NEDO-24155-1
Supplement 1
Class I
December 1978

SUPPLEMENTAL RELOAD LICENSING SUBMITTAL
FOR
NINE MILE POINT NUCLEAR POWER STATION
UNIT 1 RELOAD NO. 7
REANALYSIS SUPPLEMENT

A. INTRODUCTION

Figure 2c. Scram Reactivity and Control Rod Drive Specifications from BOC6 to EOC6 - 1500 MWd/t

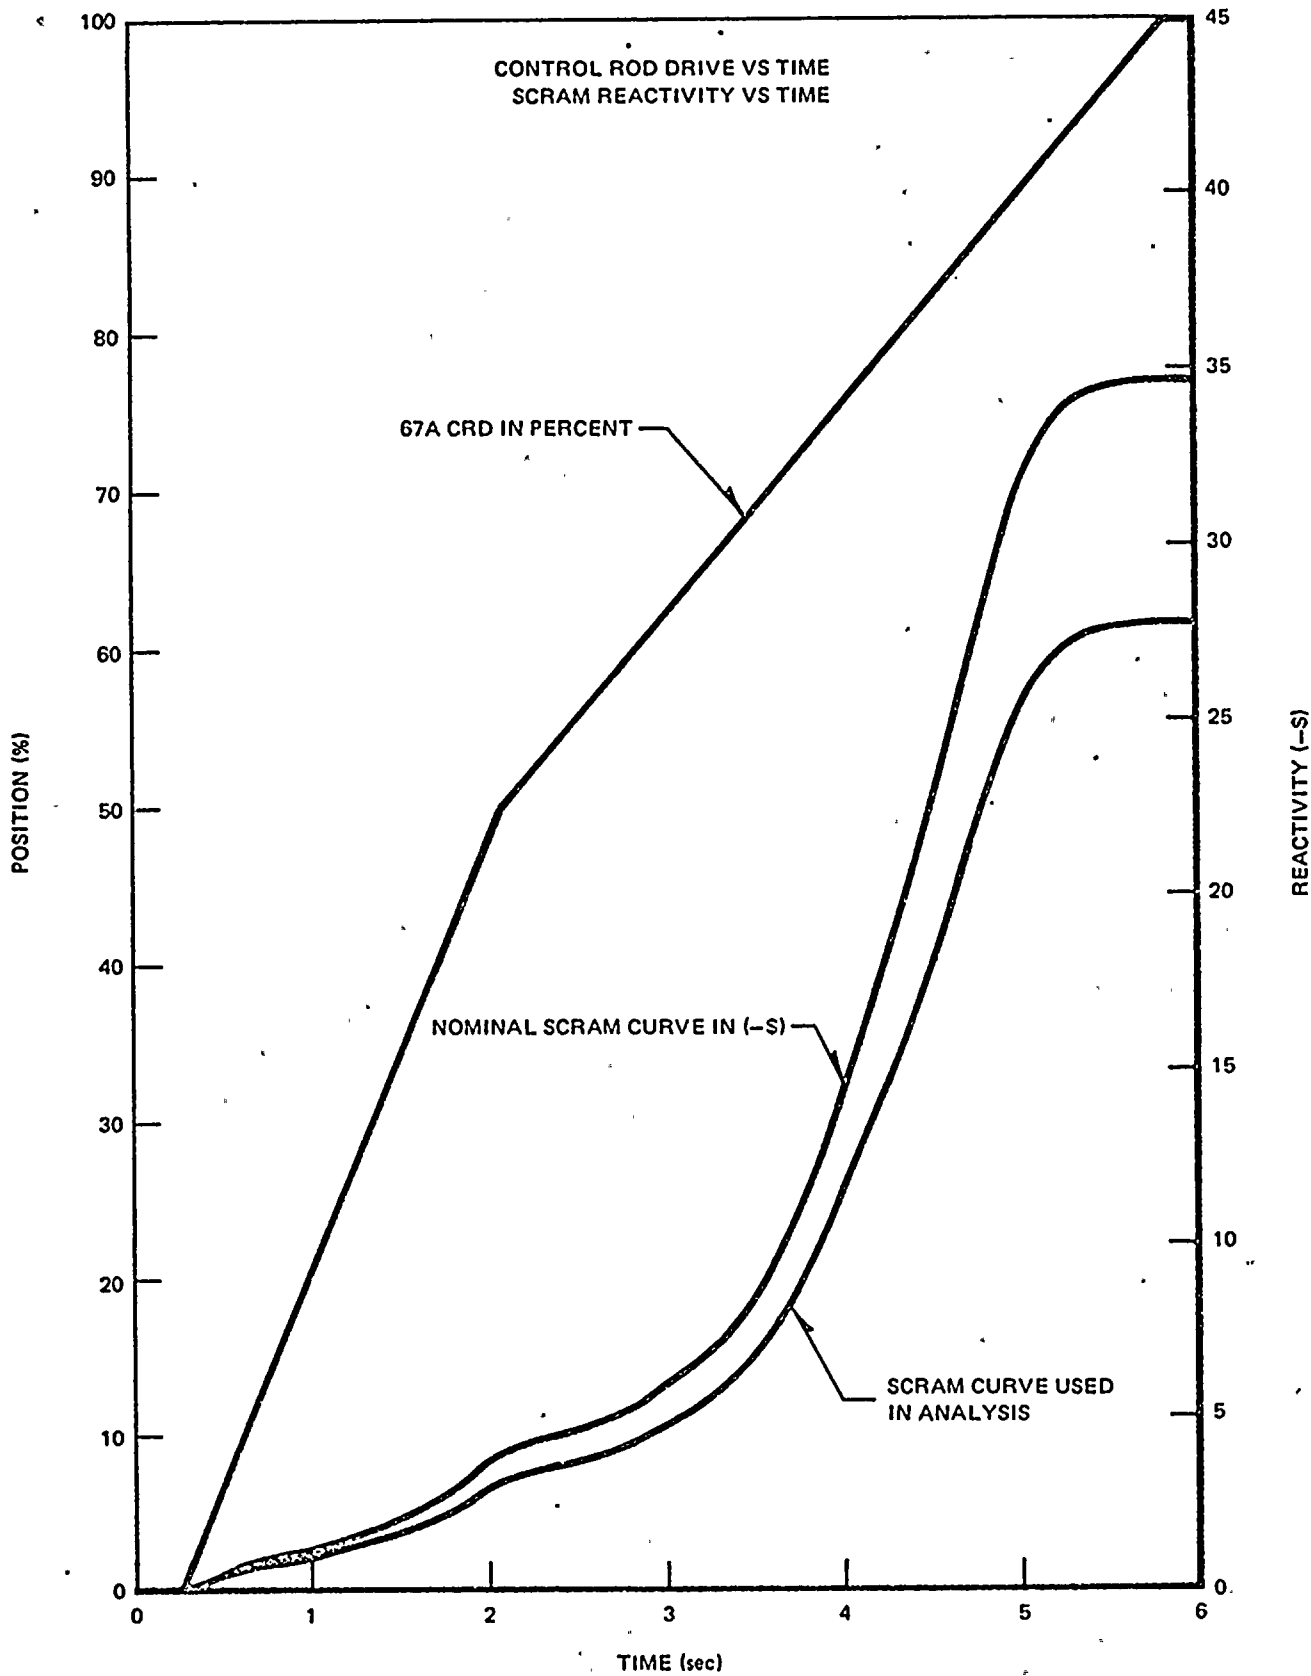
This analysis presents inputs and results at EOC6-1500 MWd/t to replace those at EOC6-2000 MWd/t in Sections 6 and 9 of NEDO-24155. Also Figures 2C and 3C of NEDO-24155 are replaced to show inputs and plant response at EOC6-1500 MWd/t. New Appendix C is added to show results of Cycle 6 load line limit analyses. The remainder of NEDO-24155 remains unchanged and is still applicable to Cycle 6.

<u>EOC6</u>	<u>EOC6 -</u> <u>1000 MWd/t</u>	<u>EOC6 -</u> <u>1500 MWd/t</u>
Void Coefficient N/A,* (c/% Rg)	-6.055/-7.569	-6.722/-8.403	-6.93/-8.66
Void Fraction (%)	35.92	35.92	35.92
Doppler Coefficient N/A (c/% °F)	-0.233/-0.221	-0.228/-0.216	-0.225/-0.213
Average Fuel Temperature (°F)	1204	1204	1204
Scram Worth N/A (\$)	-36.73/-29.38	-35.54/-28.43	-34.63/-27.7
Scram Reactivity	Figure 2a	Figure 2b	Figure 2c
